Subject: Correction of Low Pressure Fuel Lines Installation to Ensure Proper Clearance

**Vehicles Affected: 84 New Cascadia vehicles, model year 2021,
built from February 2020 through January 4, 2021**

Work Instructions

Fig. 2, Mounting Bracket and Fasteners

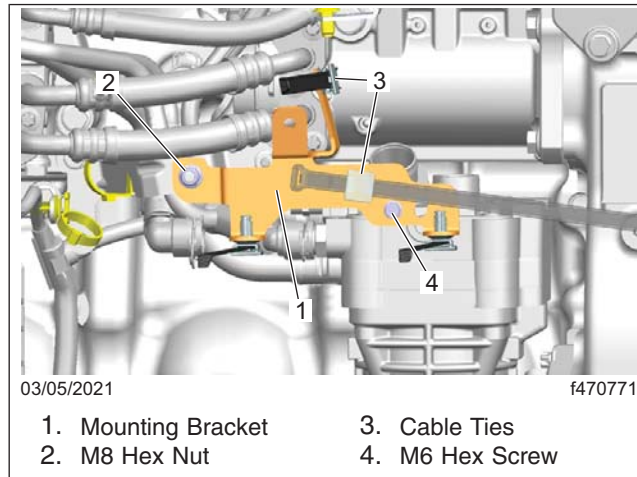
5. Remove the M8 and M6 hex nuts that attach the mounting bracket and remove the bracket. See [Fig. 2](#).

6. Using the two fasteners removed in the previous step, install the new bracket (part number A66-24315-000). Torque the M6 hex screw to $5\pm.4$ lbf-ft ($7\pm.5$ N·m). Torque the M8 hex nut to $11\pm.7$ lbf-ft (15 ± 1 N·m).
7. Attach the engine harness and fuel line to the new bracket using cable ties (part number 23-14137-000) as shown in [Fig. 2](#).
8. Verify the clearance between the fuel line and the bracket is .28 of an inch (7 mm) or greater. A tie strap should easily fit through the gap shown in [Fig. 3](#).
